# HISTORIC AND DESIGN REVIEW COMMISSION

February 03, 2021

**HDRC CASE NO:** 2021-027  
**ADDRESS:** 520 LEIGH ST  
**LEGAL DESCRIPTION:** NCB 2739 BLK LOT 4F & PT OF 5F (AKA TRACT 6)  
**ZONING:** IDZ,H  
**CITY COUNCIL DIST.:** 1  
**DISTRICT:** Lavaca Historic District  
**APPLICANT:** LABOR STREET COMMONS LLC  
**OWNER:** LABOR STREET COMMONS LLC  
**TYPE OF WORK:** Construction of a 2-story residential structure, site modifications  
**APPLICATION RECEIVED:** January 15, 2021  
**60-DAY REVIEW:** Not applicable due to City Council Emergency Orders  
**CASE MANAGER:** Stephanie Phillips

The applicant is requesting final approval to construct a new 2-story single family residence at the lot addressed 520 Leigh St. Some of the schematic documents include conceptual information about a new 3-story multifamily residential structure in the center-rear of the lot addressed 606-608 Labor St, as well as renovation work and rear additions to three 1-story historic structures on the same parcel, two of which are located along the Labor St frontage. These scopes are not included in the current request.

February 9, 2021 ELEVATIONS- single family

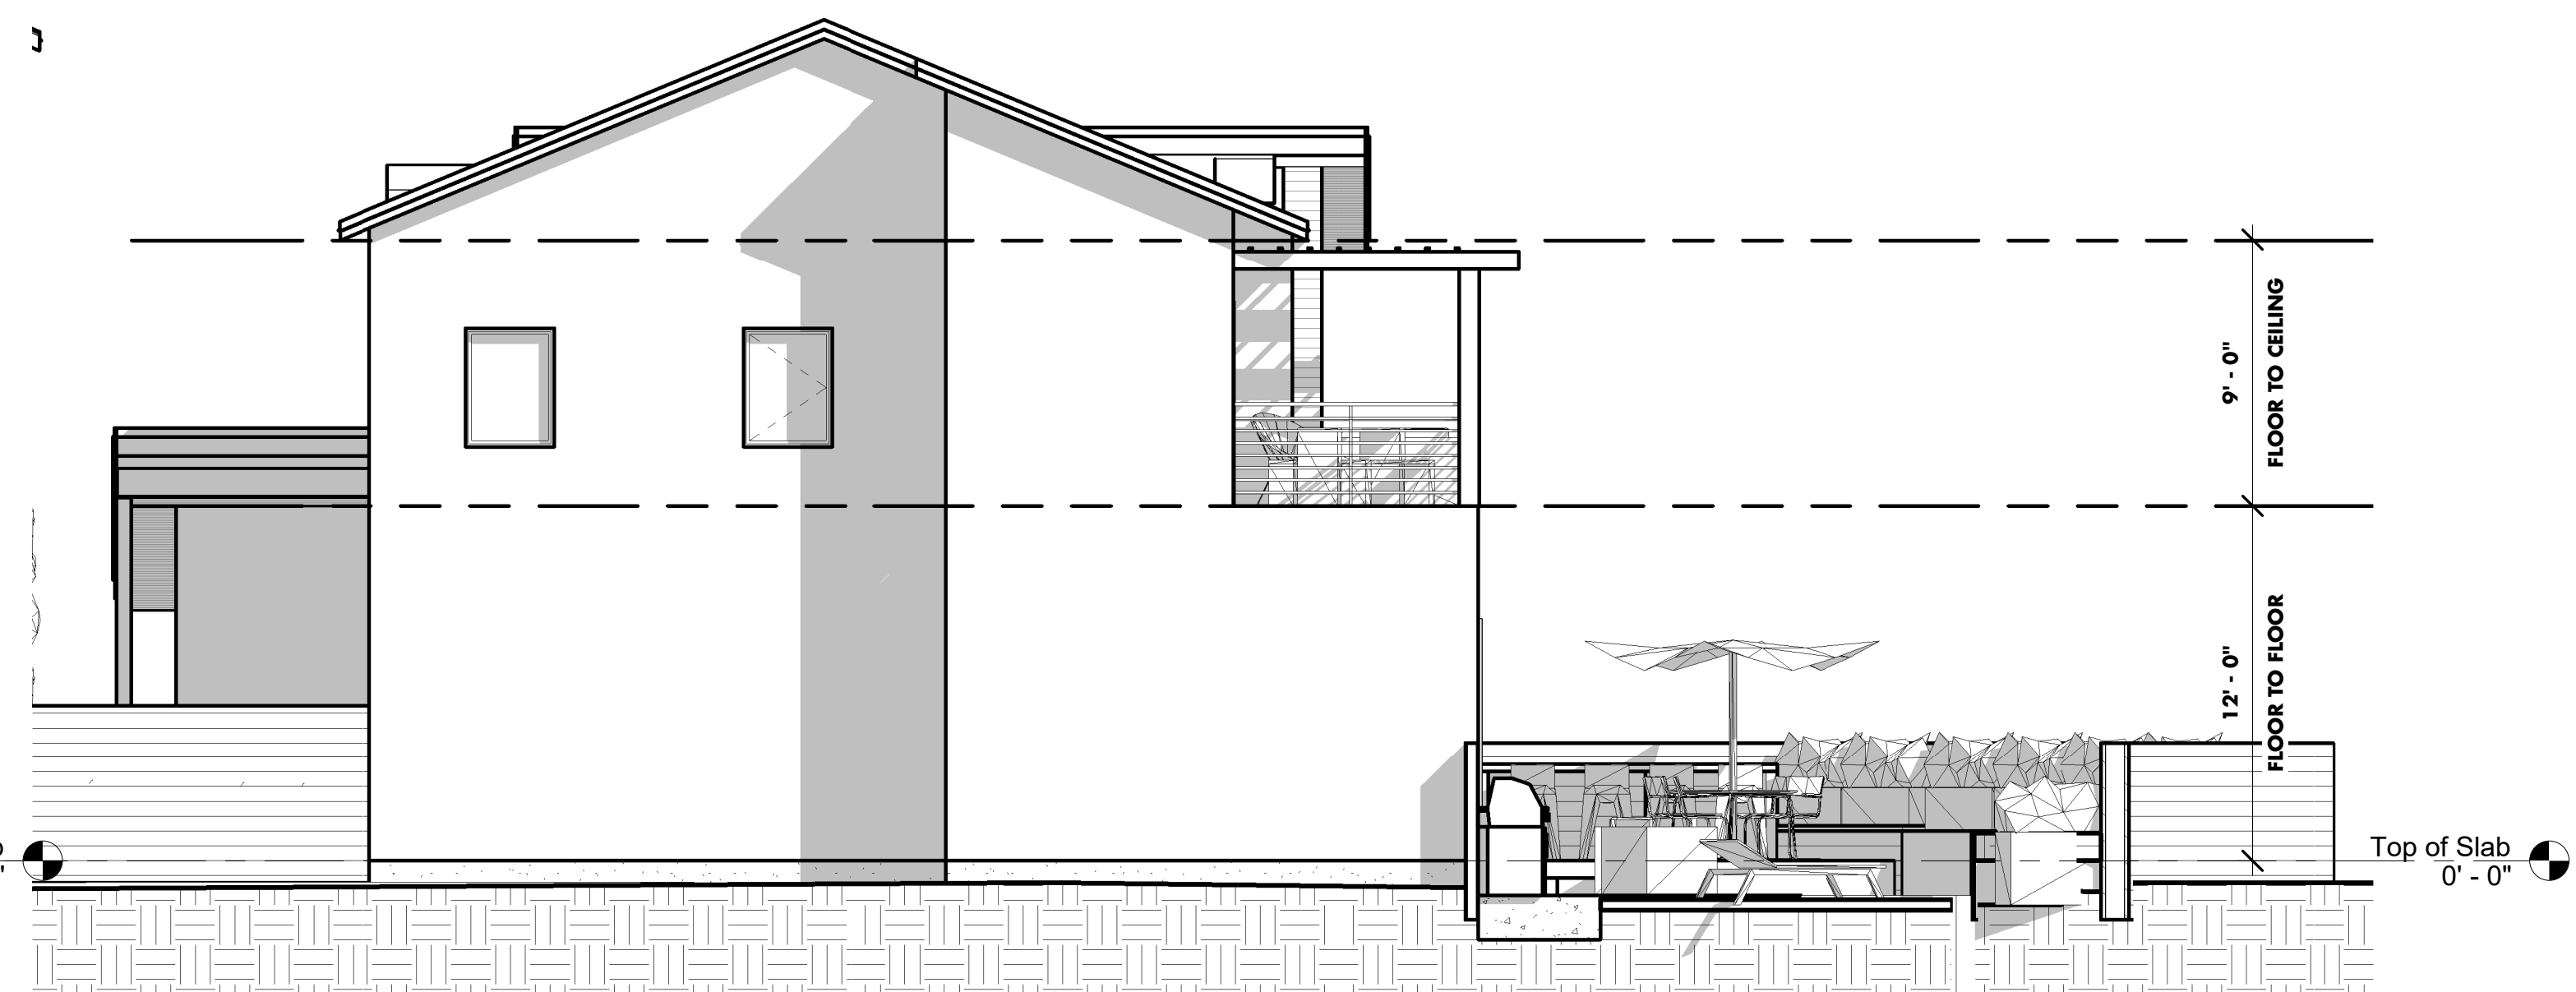
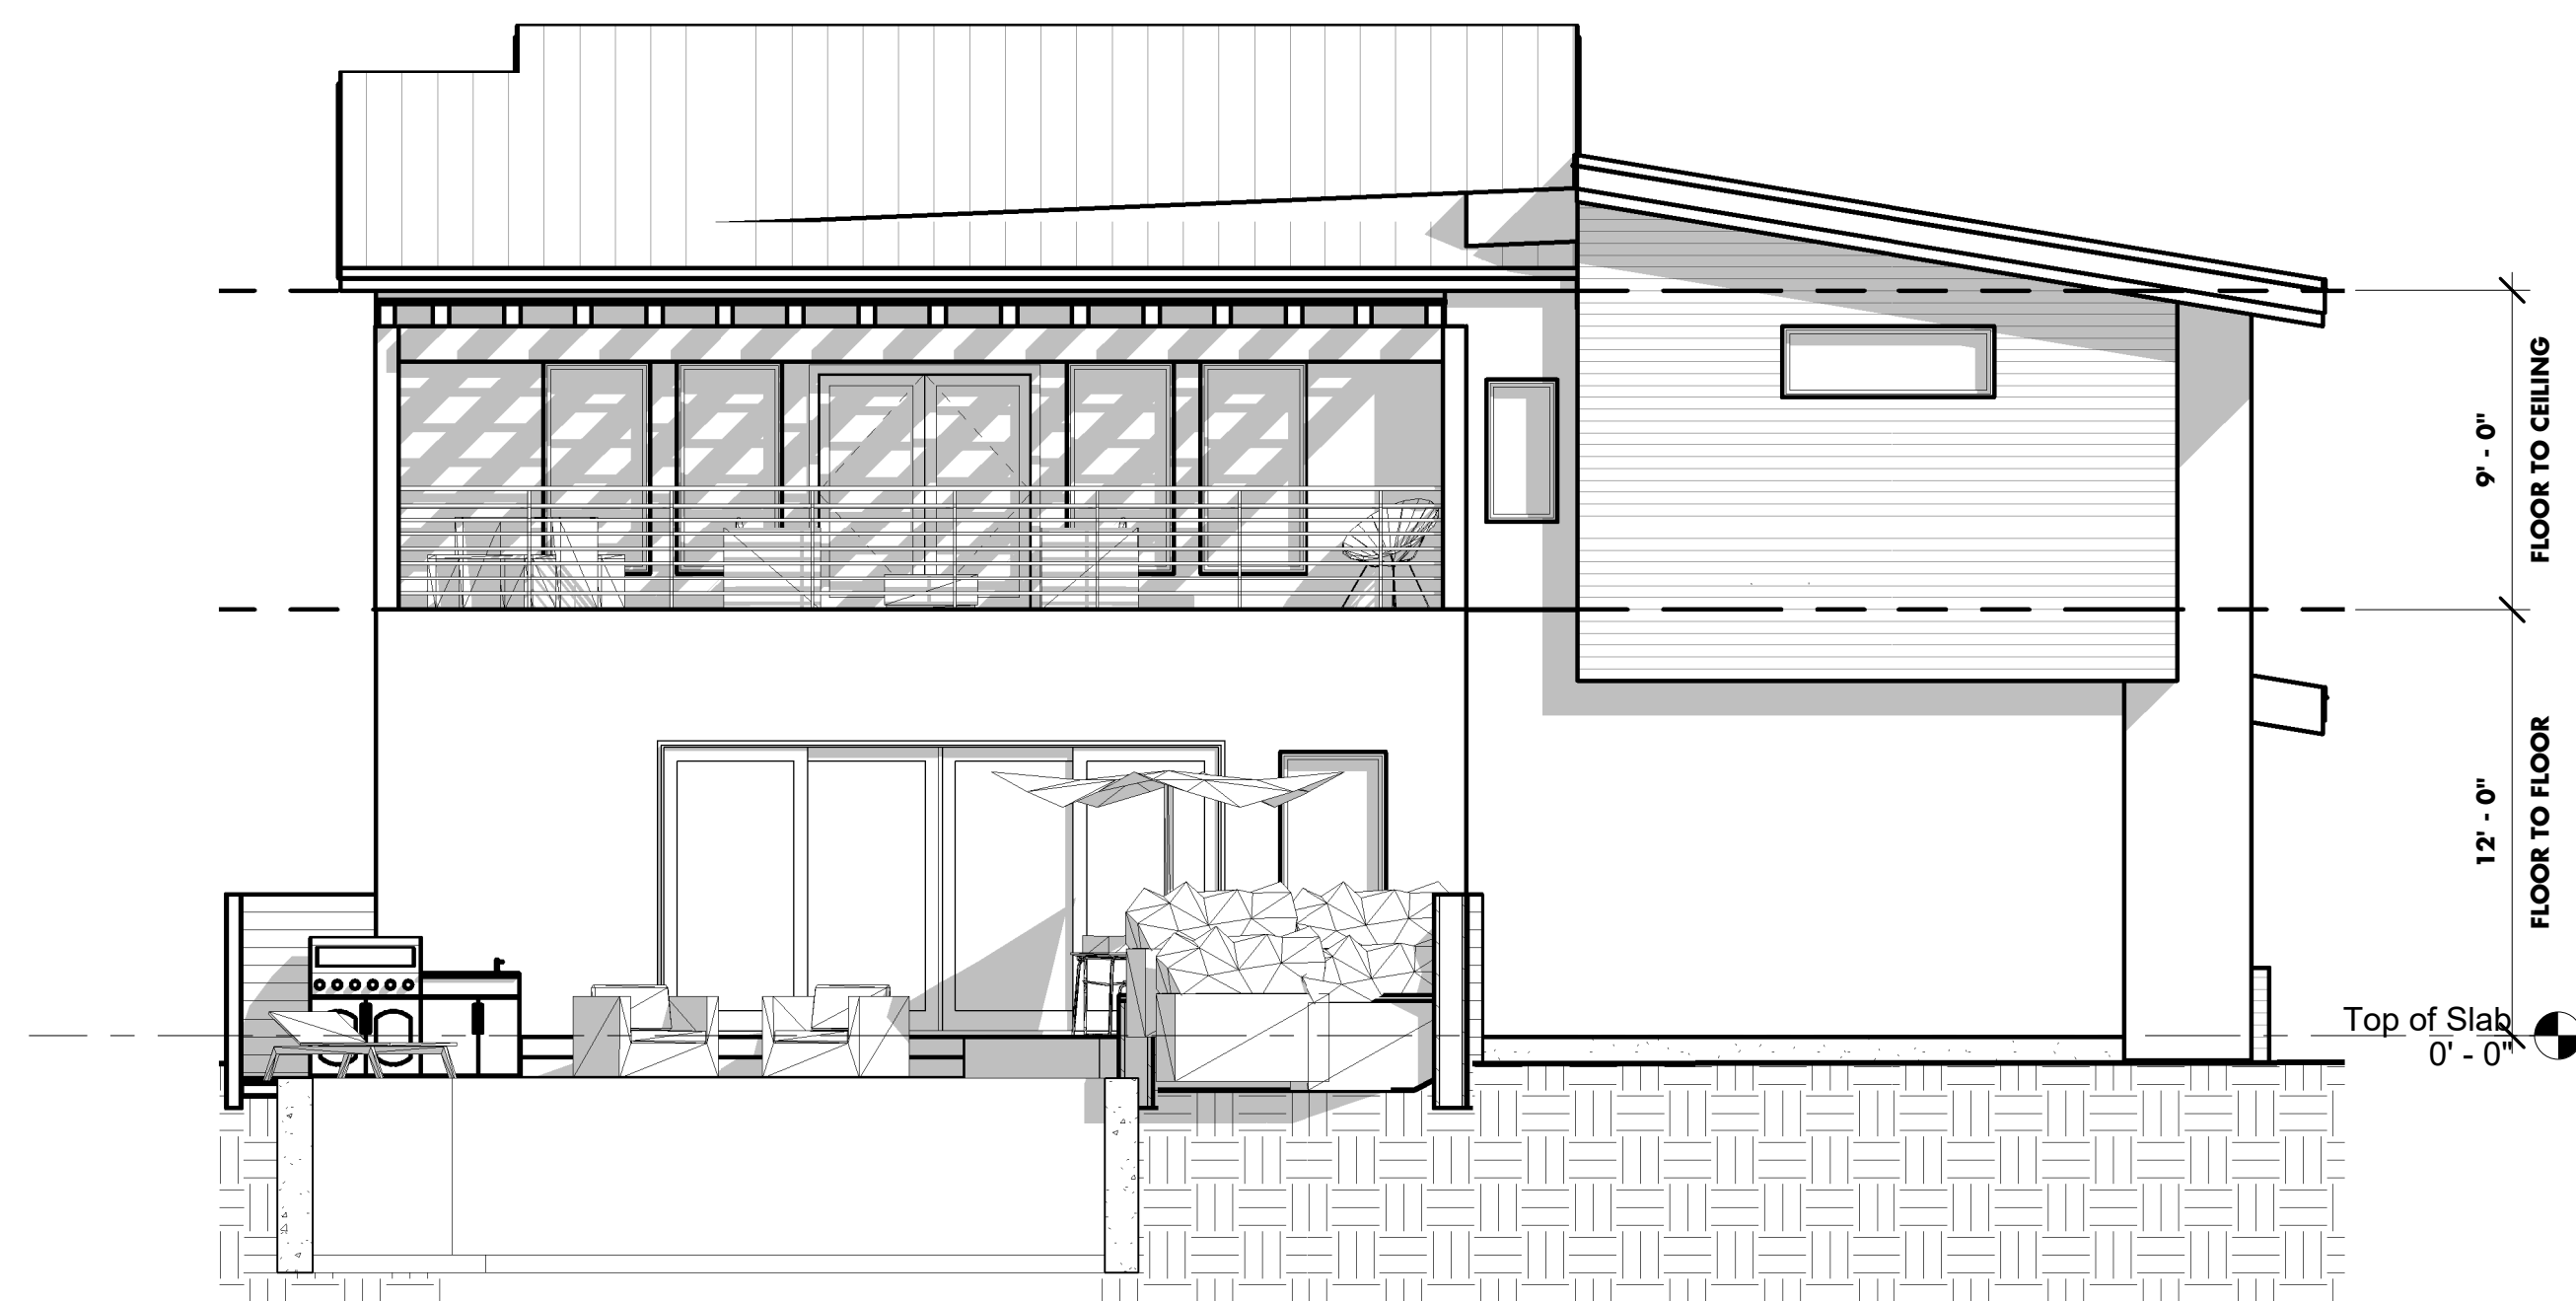
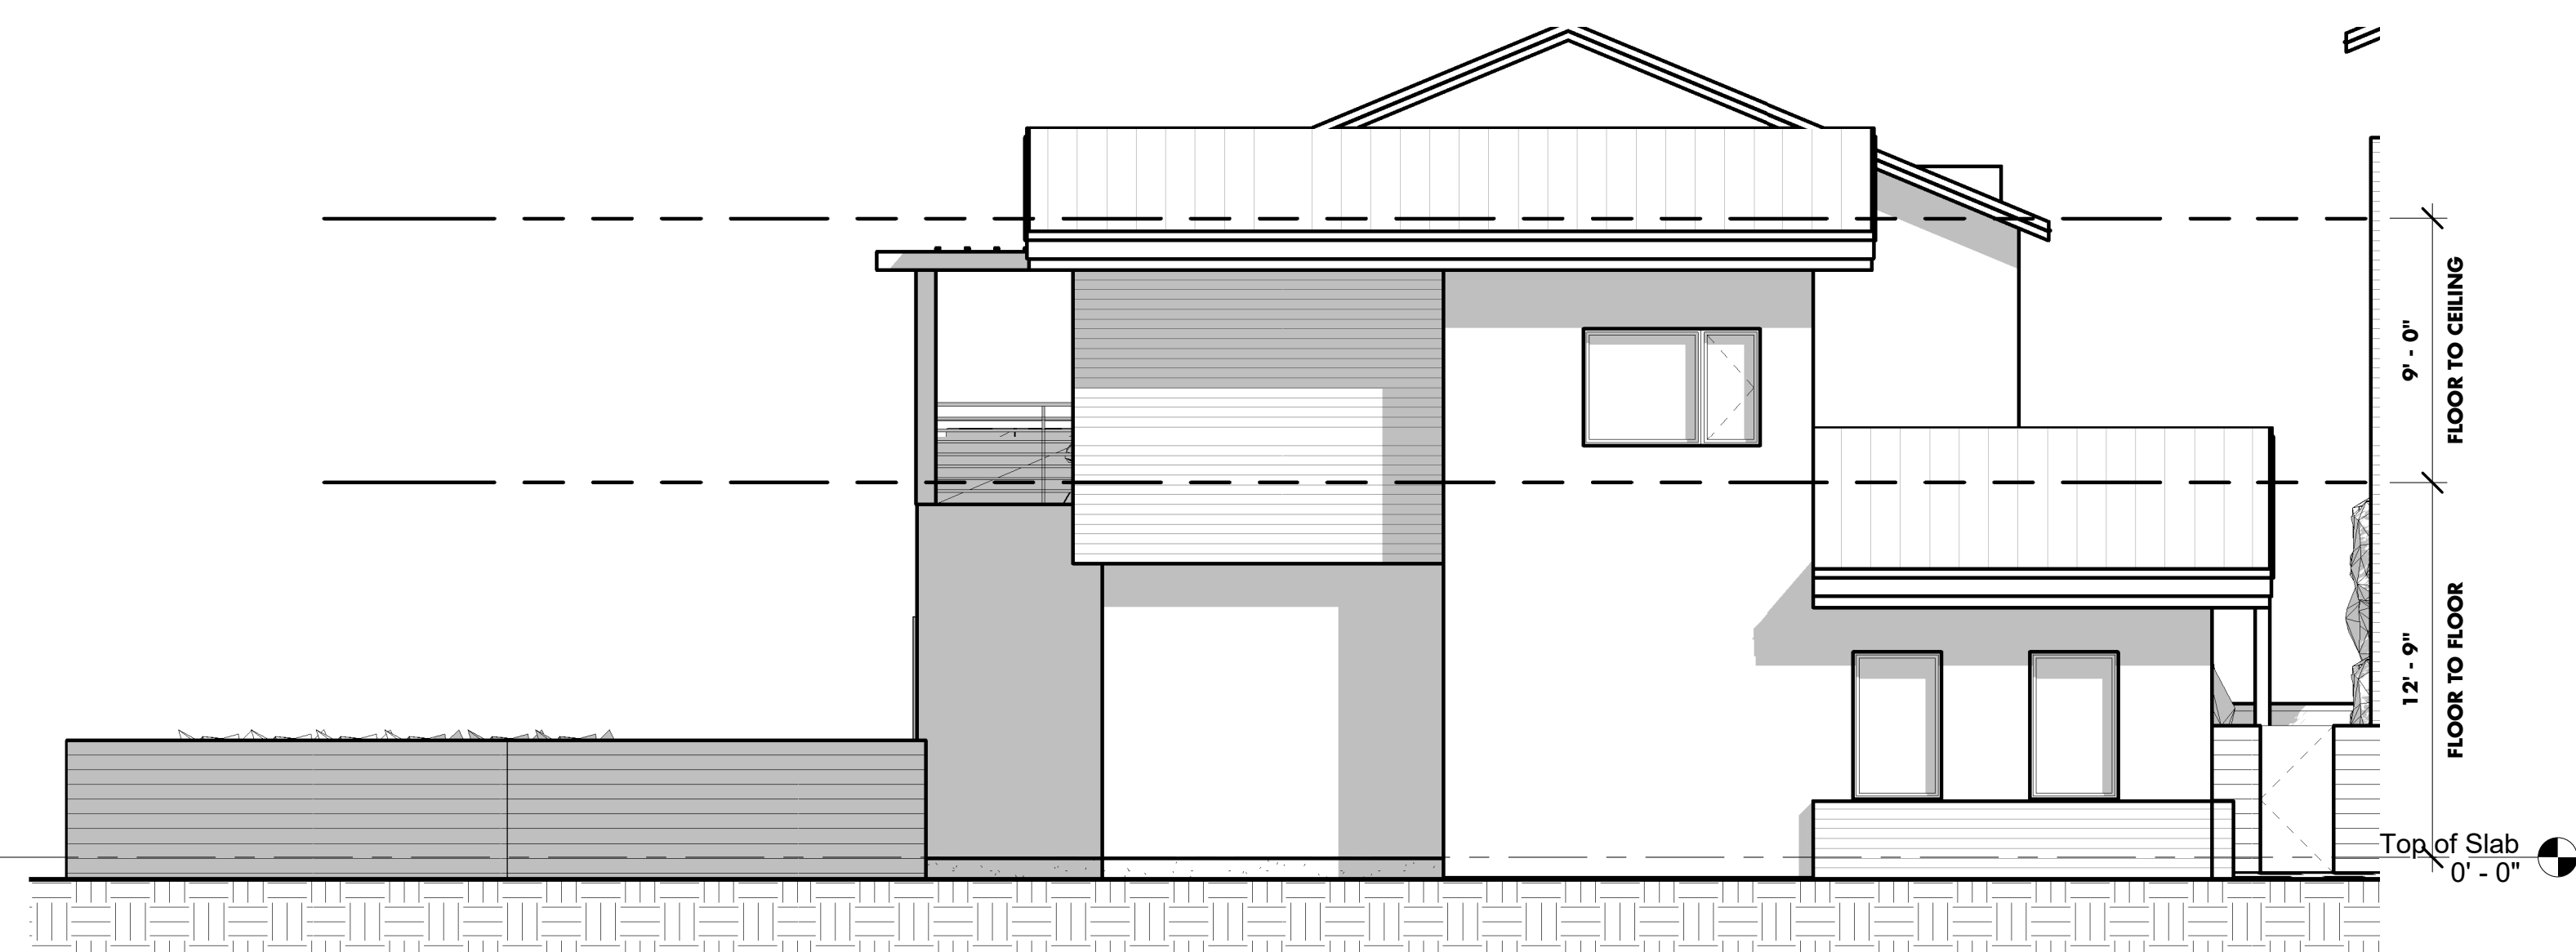
- i. **FOUNDATION & FLOOR HEIGHTS** – Per the Guidelines for New Construction 2.A.iii., applicants should align foundation and floor-to-floor heights within one foot of floor-to-floor heights on adjacent historic structures. Based on the submitted elevations, the proposed foundation is slab-on-grade with a minimal rise. Staff finds that the applicant should utilize foundation heights that are consistent with the Guidelines.

- j. **ROOF FORMS** – The applicant has proposed a multi-slope roofline. The primary roofline is a side gable with a low-sloping shed roof extending to the north. Staff generally finds these roof forms to be consistent based on the surrounding context, but finds that in context with the proportions of the home, additional roof solutions should be explored to visually reduce the mass of the flat roof portion, primarily on the north and east elevations.

- k. **WINDOW & DOOR OPENINGS** – Per the Guidelines for New Construction 2.C.i., window and door openings with similar proportions of wall to window space as typical with nearby historic facades should be incorporated into new construction. Per the elevations that the applicant has submitted, staff finds the proposed windows to be inconsistent with the Guidelines. The proposed sizes, configurations, and rhythm are not found historically within the district.

- l. **PORCH MASSING** – The applicant has proposed a front porch that consists of a stoop and roof element that is attached to the front façade of the historic structure. Porches found historically within the district feature massing that is incorporated into the massing of the structure, rather than simply attaching to the front façade, particularly in the case of two story structures. Staff finds that the proposed porch massing should be incorporated into the overall design of the structure and feature porch configurations and details that are historically found in the district.

- iii. That the applicant utilize foundation heights that are consistent with the Guidelines, as noted in finding i.
- iv. That the applicant incorporate roof forms that are more consistent with the surrounding historic context as noted in finding j.

- v. That the applicant incorporate appropriate window sizes and proportions and modify the overall fenestration pattern as noted in finding k.
- vi. That the applicant incorporate appropriate front porch massing as noted in finding l.

**Rendering looking directly at 522 Leigh Street**

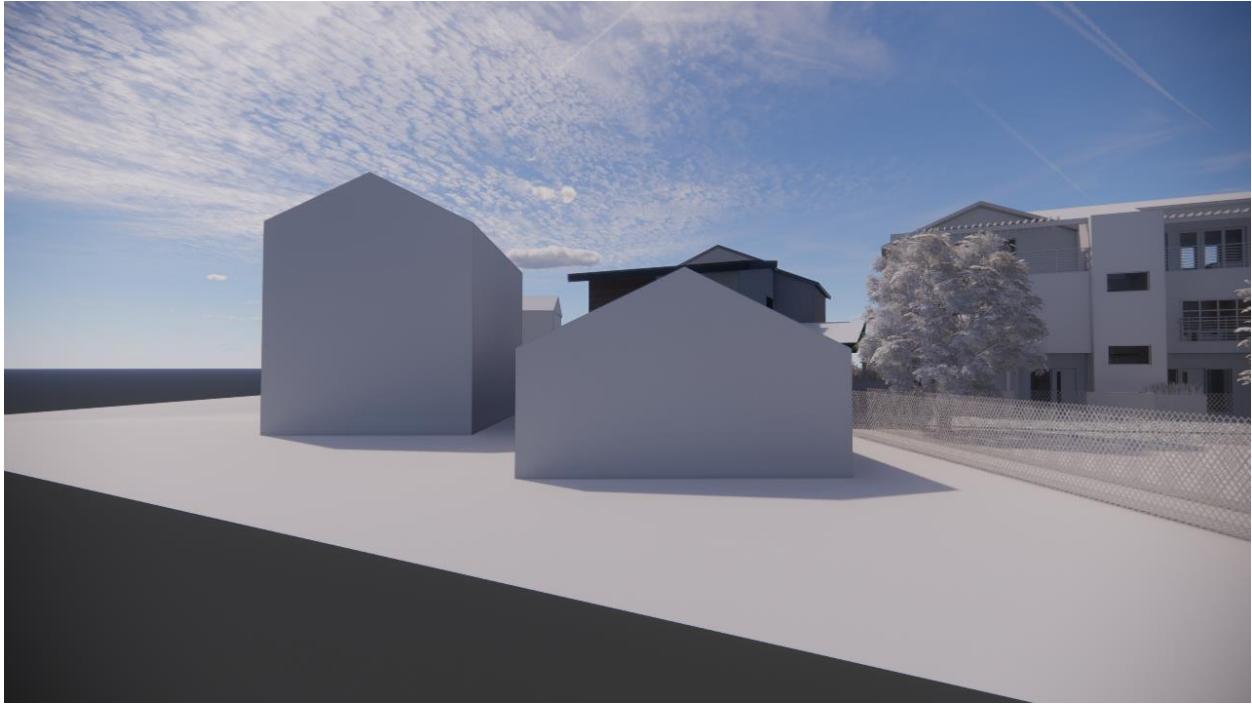
**STAFF NOTE: THREE STORY  
STRUCTURE IS NOT EXISTING AND  
HAS NOT BEEN REVIEWED OR  
APPROVED BY OHP OR HDRC**

**Rendering looking directly South from Leigh Street**

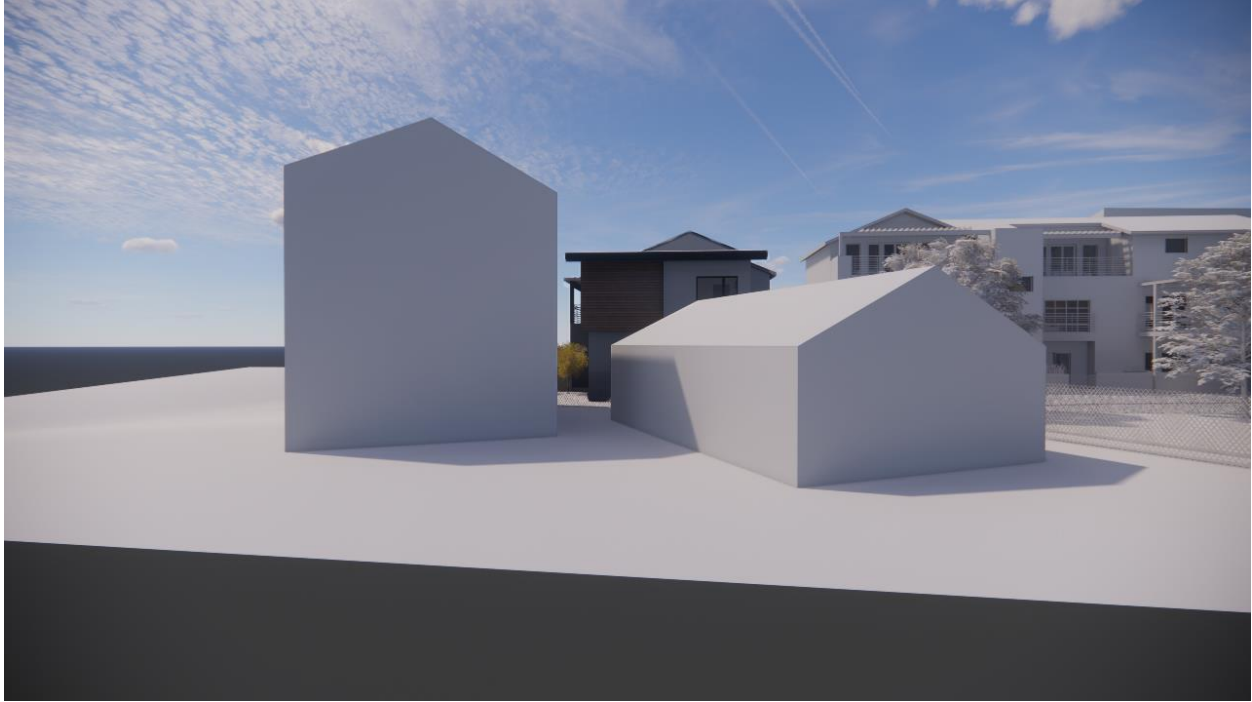
**STAFF NOTE: THREE STORY  
STRUCTURE IS NOT EXISTING AND  
HAS NOT BEEN REVIEWED OR  
APPROVED BY OHP OR HDRC**
